T10/07-157 revision 4

Date: September 25, 2007

From: George Penokie (IBM)

Subject: SAM-4: Changes requested from 03/2007 editing session

Figure 3 — SCSI Port class diagram

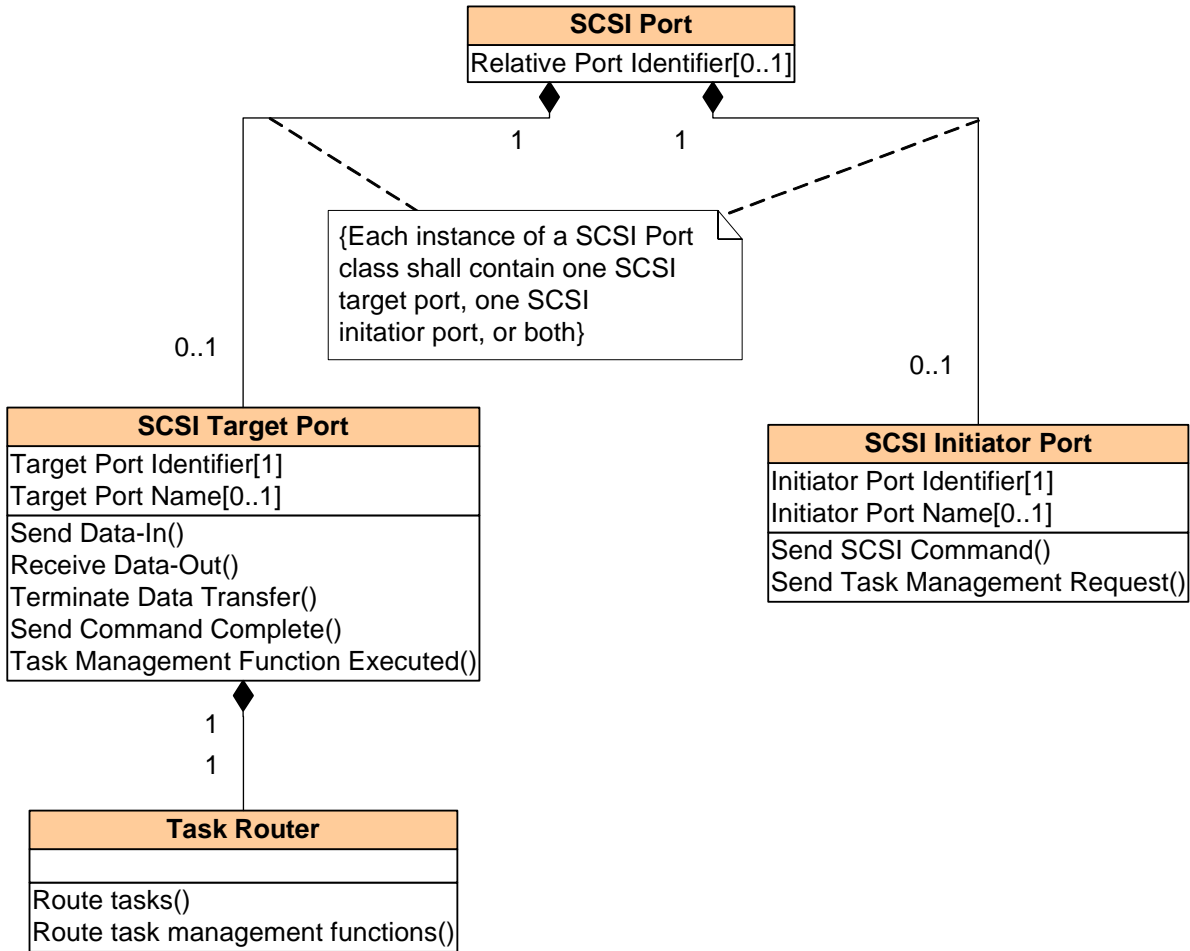
A The SCSI Port class (see figure 3) contains the:

- a) SCSI Target Port class (see 4.4.3) ~~that contains the:~~
A) Task Router class (see 4.4.5);
- b) SCSI Initiator Port class (see 4.4.4.1); or
- c) both.

A [The SCSI Target Port class](#) (see figure 3) contains the:

[The SCSI Initiator Port \(see figure 3\) class processes the:](#)

Figure 4 — SCSI initiator device class diagram

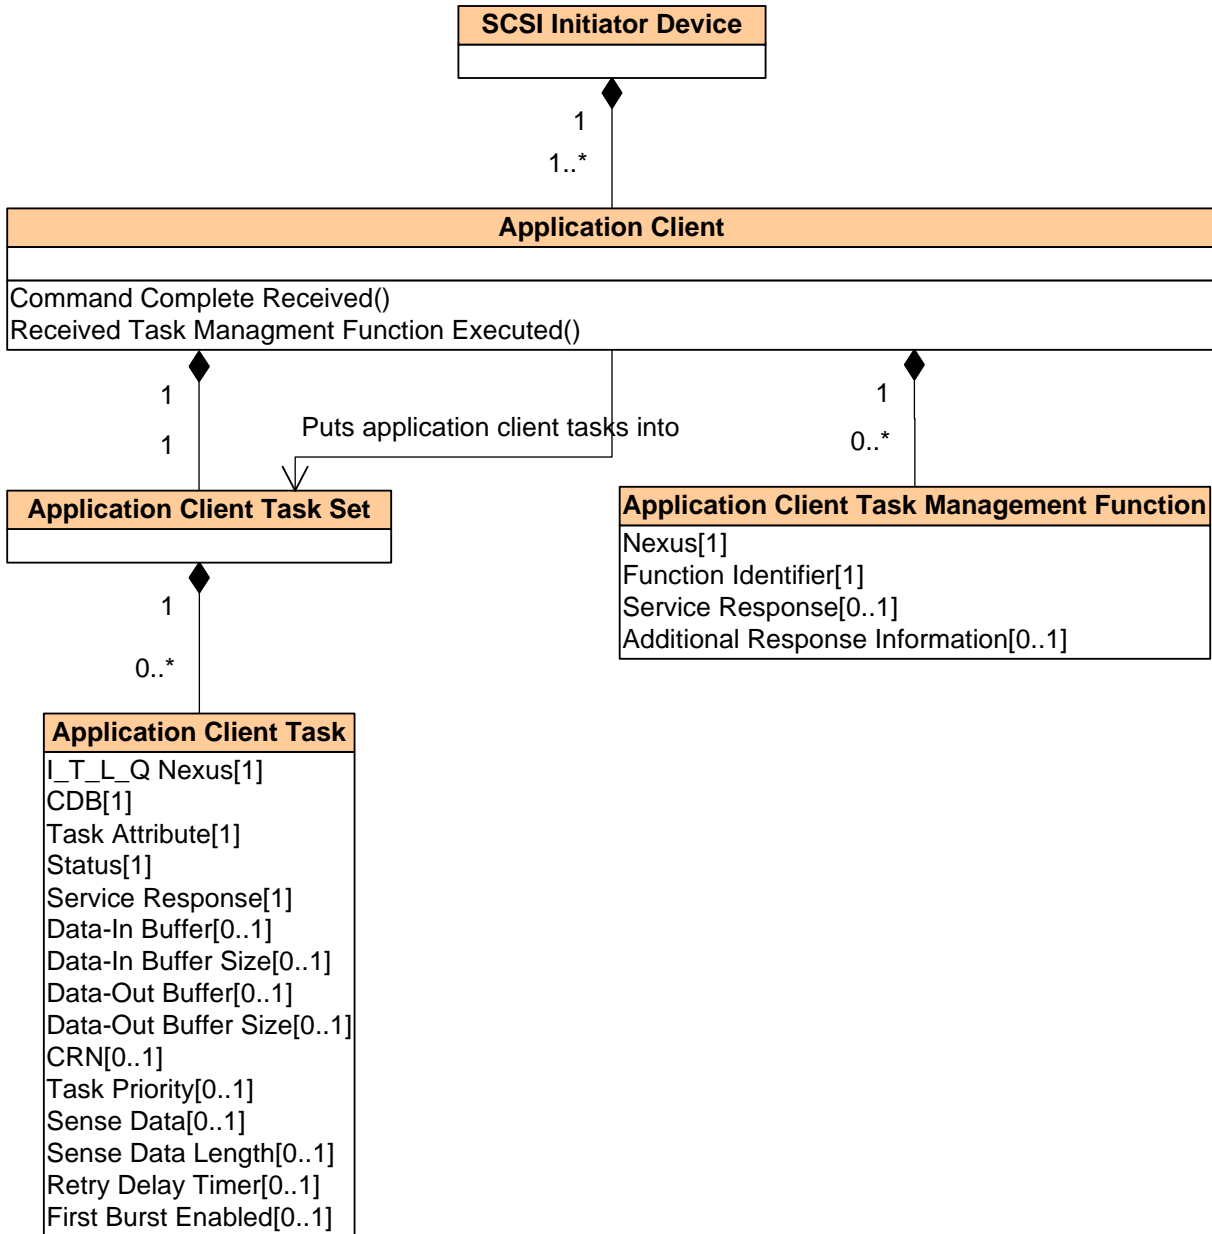
[The SCSI Initiator Device class \(see figure 4\) is a SCSI Device class that contains the:](#)

- a) [Application Client class \(see 4.5.10\).](#)
- a) ~~A SCSI initiator device class (see figure 19) is a SCSI device class that contains the:~~
 - A) ~~Application Client class (see 4.5.10) that contains the:~~ and:
 - B) ~~application-client task class.~~

[The Application Client class \(see figure 4\) contains the:](#)

Figure 5 — Logical unit class diagram

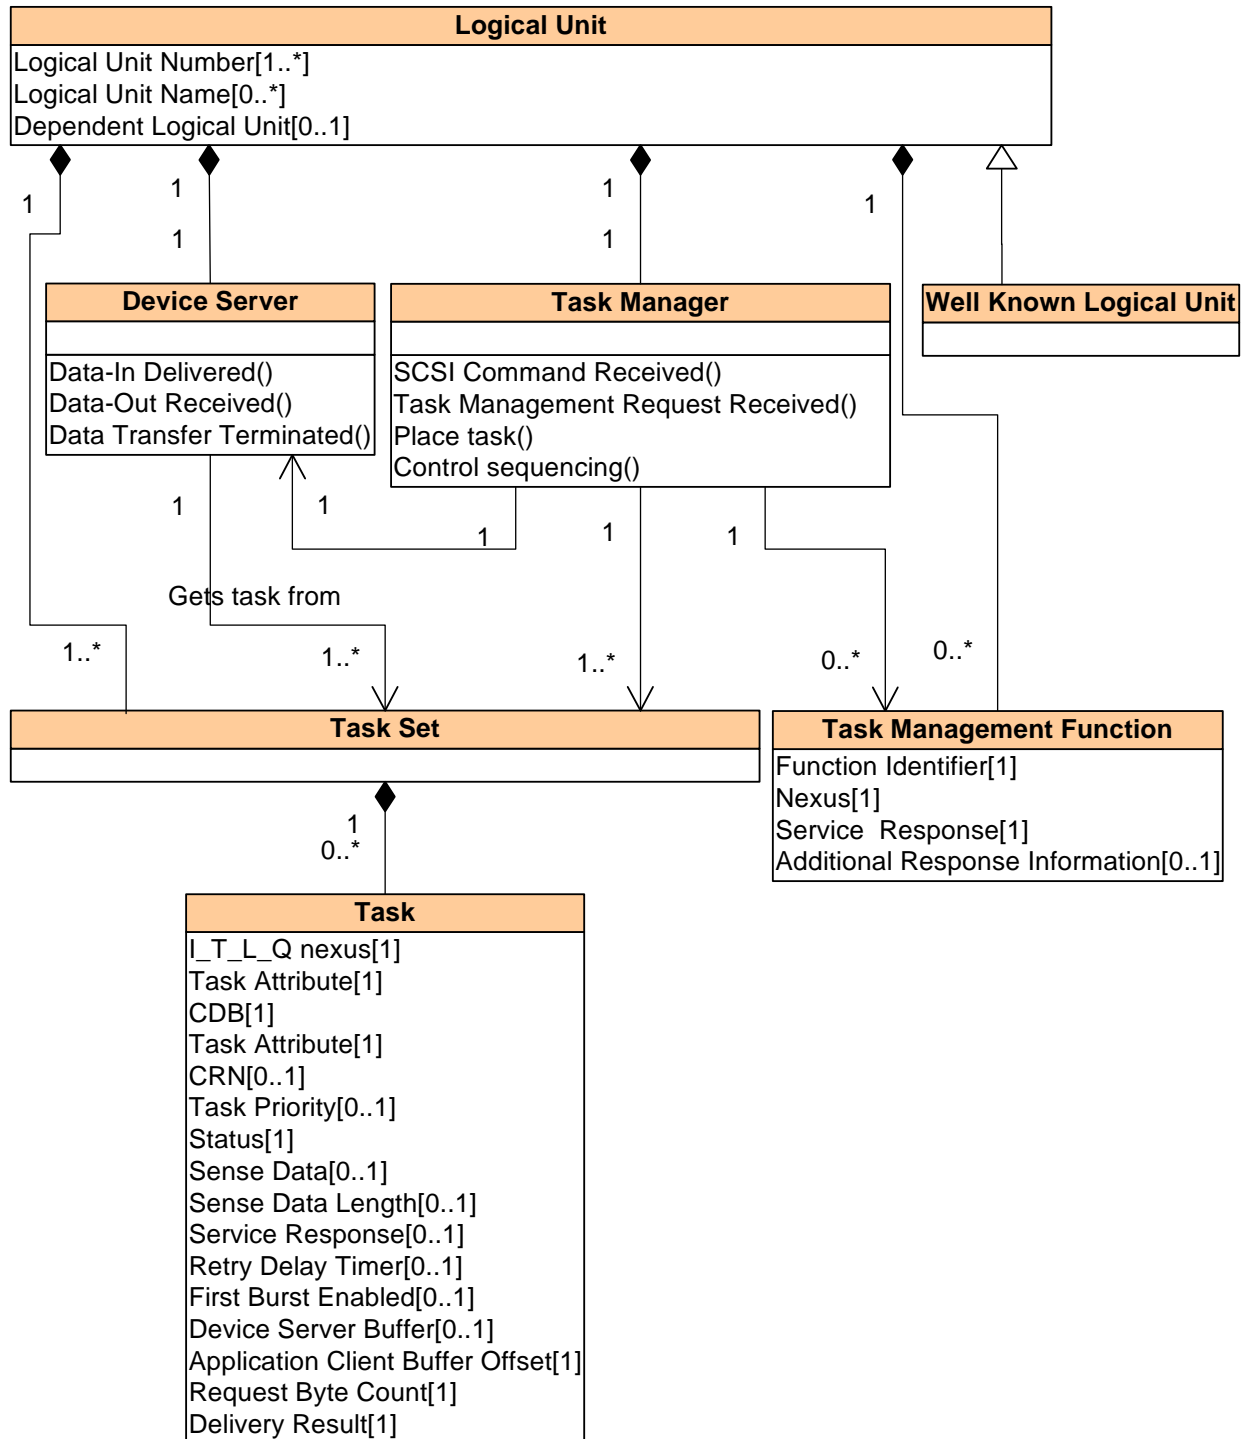
A The Logical Unit class (see figure 5) contains the:

A The Logical Unit class (see figure 5) may be substituted with the:

- a) Well Known Logical Unit class (see 4.5.24.1); or
- b) Hierarchical Logical Unit class.
